FINAL PLAT

BROCK SECOND ADDITION

Re: S/D 96-74 - BROCK SECOND ADDITION (Final Plat)

Re: S/D 96-74 - BROCK SECOND ADDITION (Final Plat)

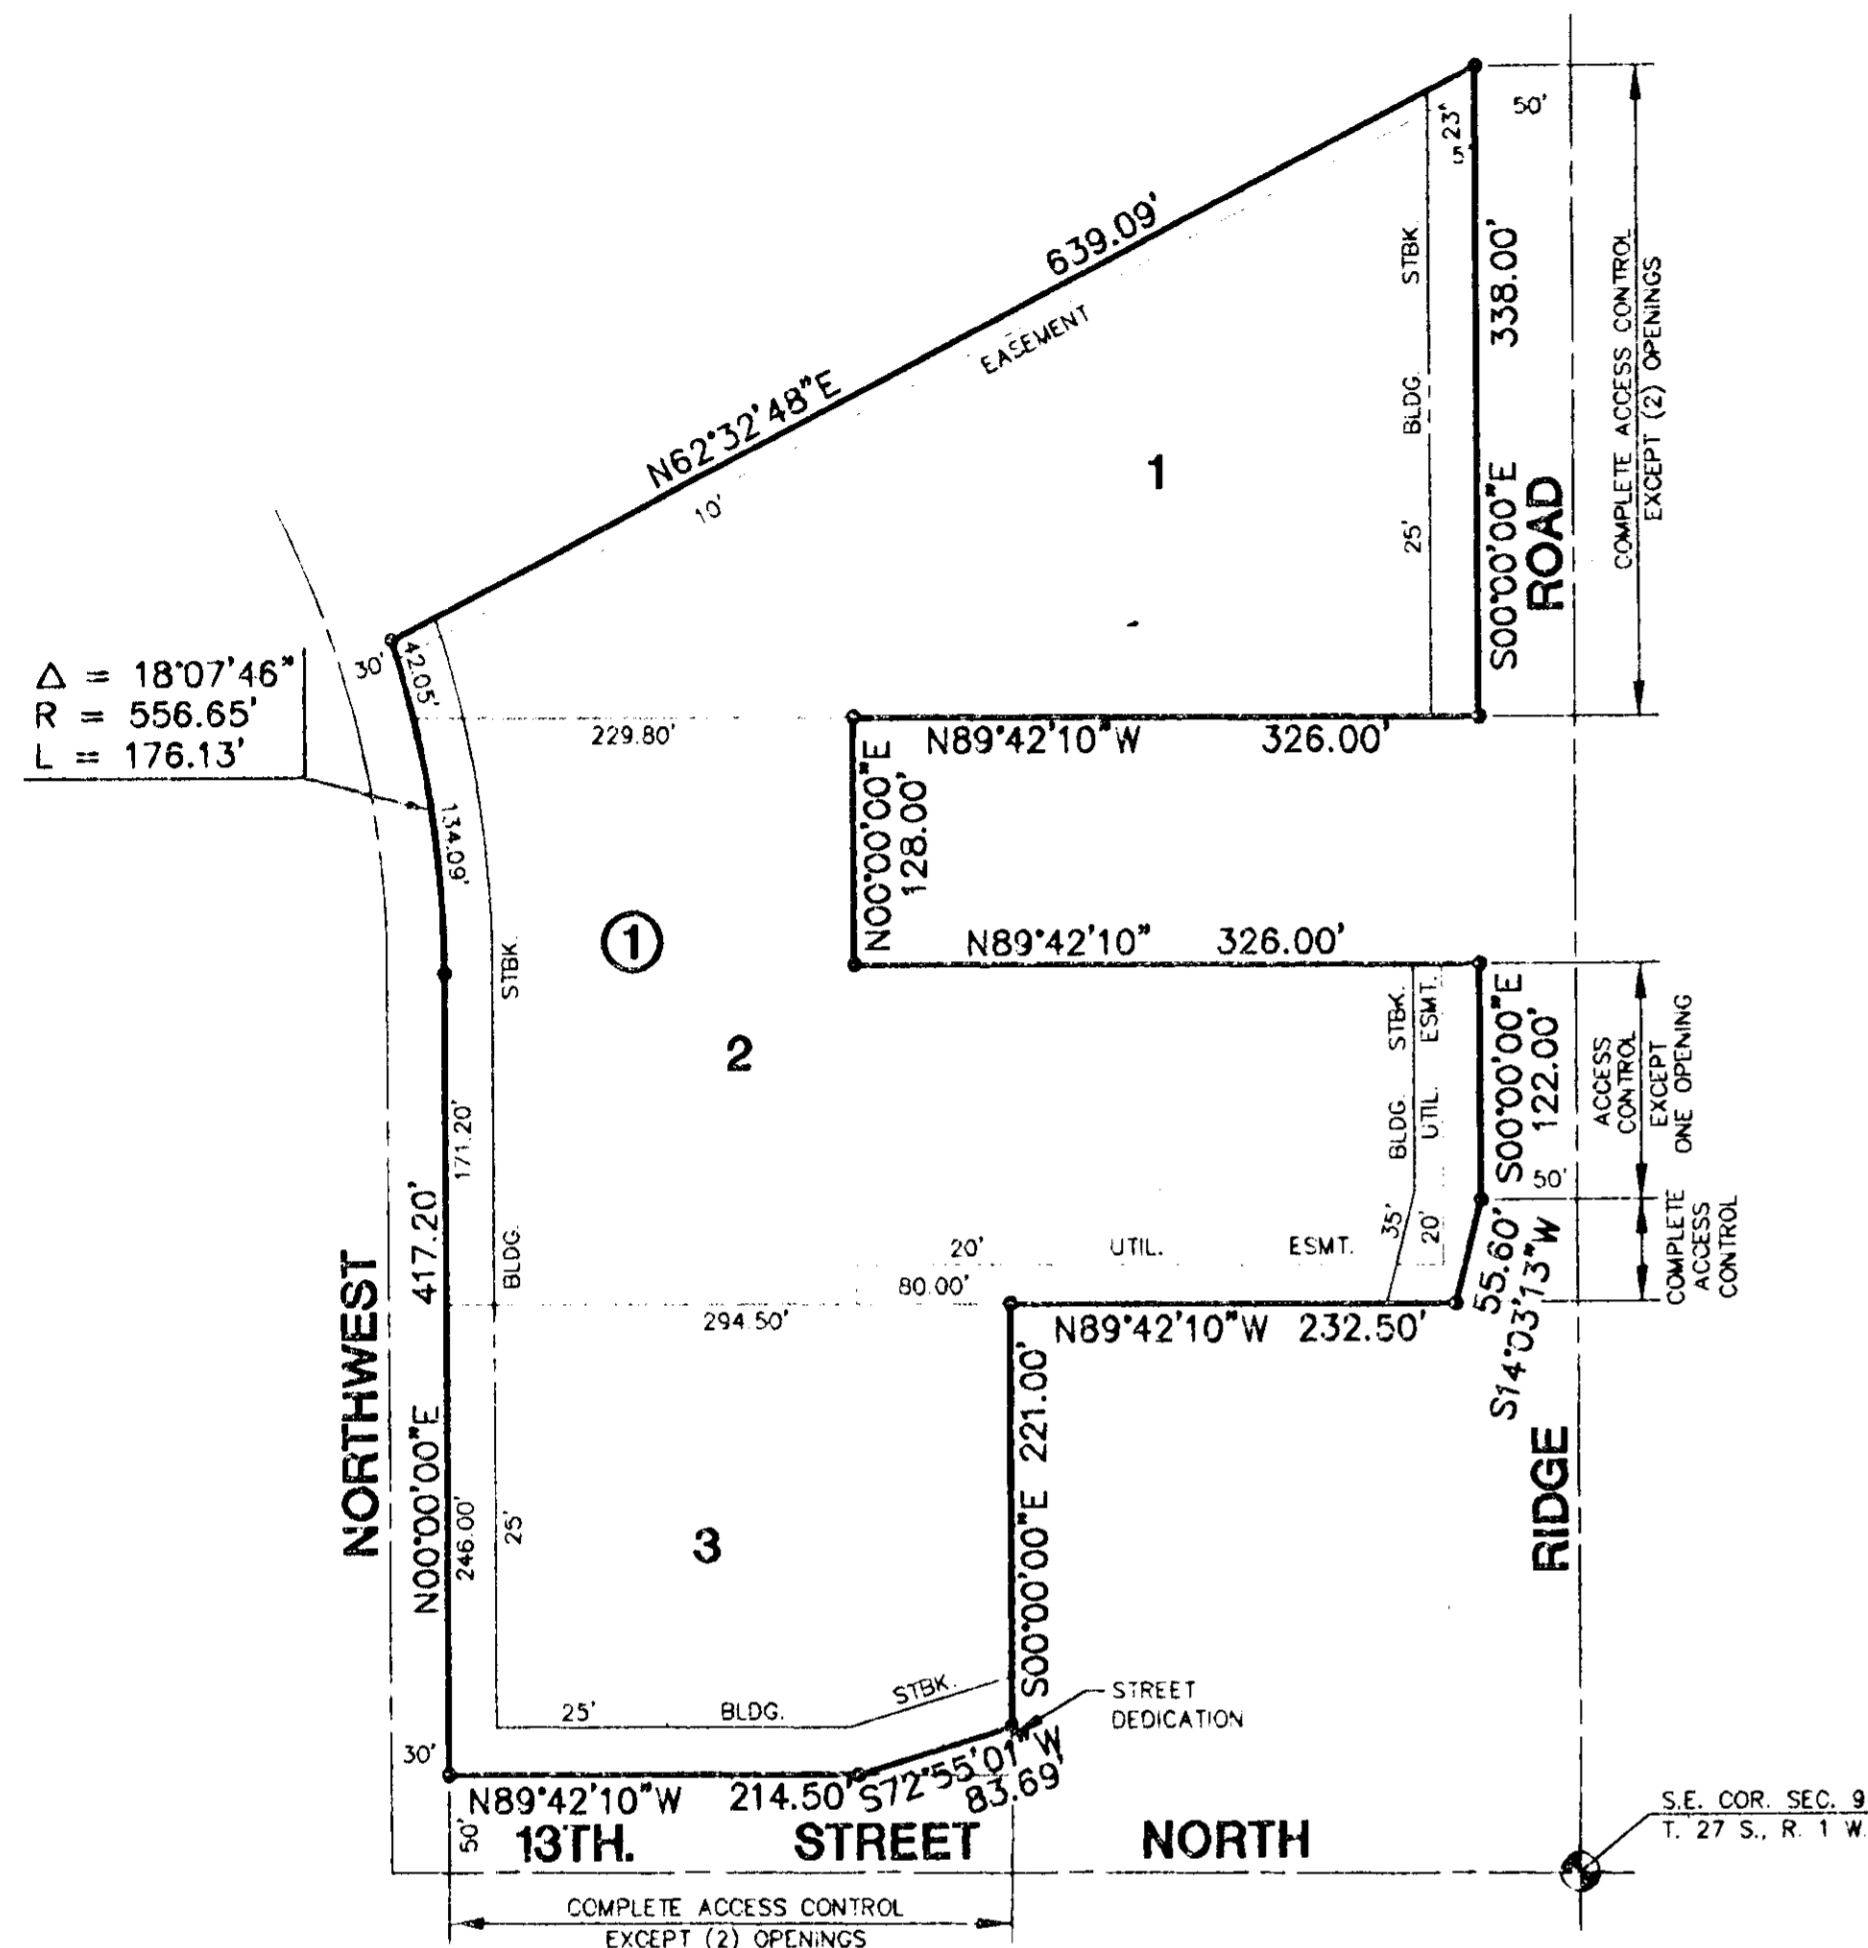
- A. At the time of site development, this property shall provide any needed drainage, including storm sewer, improvements.
- B. In regard to the final plat tracing, the applicant shall either:

Submit a 3-lot plat as proposed but with the dedication of complete access control to Northwest Parkway from the adjacent lots. Cross-lot access agreements for Lot 2 to use access through adjacent Lots 1 and 3 to Ridge Road and 13th Street North shall also be provided. For Lot 2, as required by the City's Fire Department, an emergency access easement shall be shown to Northwest Parkway and any related improvements shall be agreed to (curbing, gates, etc.). Any such easements shall be clearly indicated in the plat and shall be unencumbered by parking spaces or any other possible obstructions.

However, if the applicant is unable to secure cross-lot access agreements for Lot 2, from the adjoining property owners involved in this plat, a one-lot plat may be submitted for City Council approval. One "temporary" opening shall be allowed to Northwest Parkway in such case. The plat's text shall note in this case, that complete access control is contingently dedicated such that upon the future platting of these adjoining parcels, if cross-lot access is obtained at the time of such properties platting, that access to Northwest Parkway will be discontinued and that the existing opening will be converted to an emergency access opening only.

- C. Since an opening or openings is to be provided for Lots 1 and 3 to the adjacent streets, the word "complete" shall be deleted from those areas where access is being provided.

- D. On the final plat tracing additional information shall be shown in regard to this plat's tie point. Specifically, a dimension should be indicated from the Southeast corner of Section 9 to one of the plat's corners and/or a tie point also indicated to an existing lot.

- E. On the final plat tracing, an appropriate title should be indicated for Mark Stanford of Cooperstown, Inc. on the plat's signature line.
- F. On the final plat, the MAPC Chairman shall be indicated as John C. Frye.
